**DATE**: June 5, 2015 **ARC REVIEW CODE**: R15060201

**RE:** Development of Regional Impact Review - Notification Only

Name of Proposal: Decatur Crossing Phase 1 and 2

#### **DECATUR CROSSING PHASES 1 AND 2 DRI**

ZONING SITE PLAN

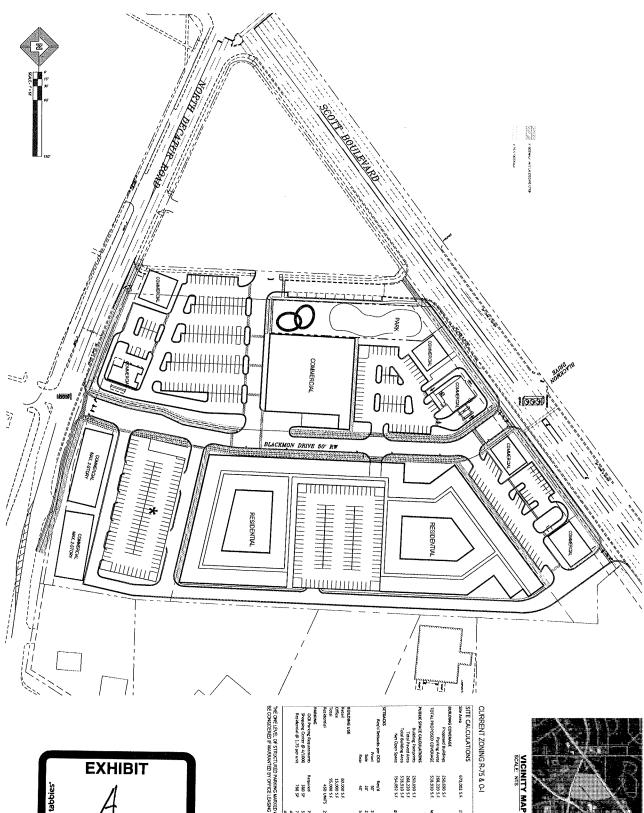
The proposed Phase 1 of the development will have 385 parking spaces in a parking deck. The proposed Phase 2 will have 517 parking spaces to serve the retail part of the development, and 720 spaces for the residential part of the development. This results in a total of 1,622 parking spaces. The Phase 2 site plan notes that a separate, one-story parking deck may also be constructed if warranted by office leasing demands. No additional detail is provided about this structured parking on the site plan.

A traffic study was not conducted, so no transportation improvements were recommended for the roadway network. However, the site plan shows new traffic signals at the following intersections:

- Scott Boulevard/US 29/US 78/SR 8 at Blackmon Drive
- North Decatur Road at Blackmon Drive

The site plan shows new traffic signals at the following intersections:

- Scott Boulevard/US 29/US 78/SR 8 at Blackmon Drive
- North Decatur Road at Blackmon Drive

The applicant shall ensure that these proposed signals meet all applicable DeKalb County and/or GDOT requirements for signal spacing, signal warrants, and operations.
